## D/DRC Case

1520 Hagood Avenue

**DESIGN/DEVELOPMENT REVIEW COMMISSION**  
**DESIGN REVIEW DISTRICT**  
**HISTORIC AGENDA**  
**EVALUATION SHEET**  
Case # 2

**NATURE OF REQUEST:** Request Certificate of Design Approval for exterior change

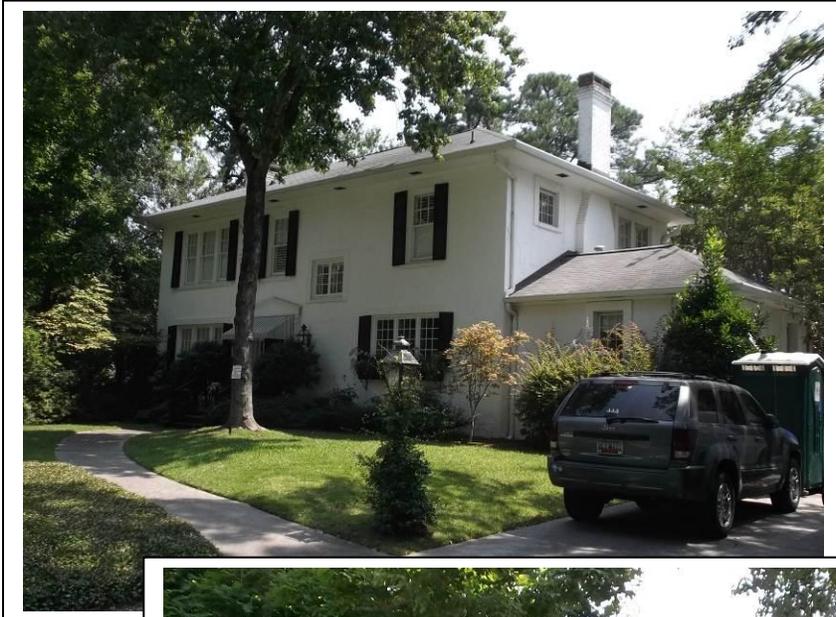
The original front porch roof and support structure are missing, and there is no documentation as to the original appearance of those features. Other homes of a similar style and period, the 1920s, have door hoods that are similar to what is being proposed. This home has a mixture of Colonial Revival and Prairie style features, with elements such as asymmetry, grouped windows, and generous eaves. Therefore it is difficult to determine what the original porch looked like. A home that appears to be from the same era, located two lots to the south, has a gabled porch roof with arched ceiling, similar to what is proposed, though it is supported by columns rather than brackets.

The proposed door hood will span the width of the door surround and attach to the front of the existing fluted pilasters. It is unknown if the existing pediment and pilasters are original, given that they may have been added after the removal of the front porch. The new gabled door hood will feature a standing seam or copper roof, which is appropriate for small items such as this and is not in conflict with the existing asphalt shingle roof on the remainder of the house. The heavy brackets will be approximately four feet in height, supporting an entablature with a series of moldings, while the ceiling of the hood forms an arch across the width of the doorway. These features are common for door hoods from the 1920s and would be compatible with the structure; the rectangular shape of the front doorway does not preclude the use of the arched ceiling and in fact it is typical to find such features together on Colonial Revival examples of the type.
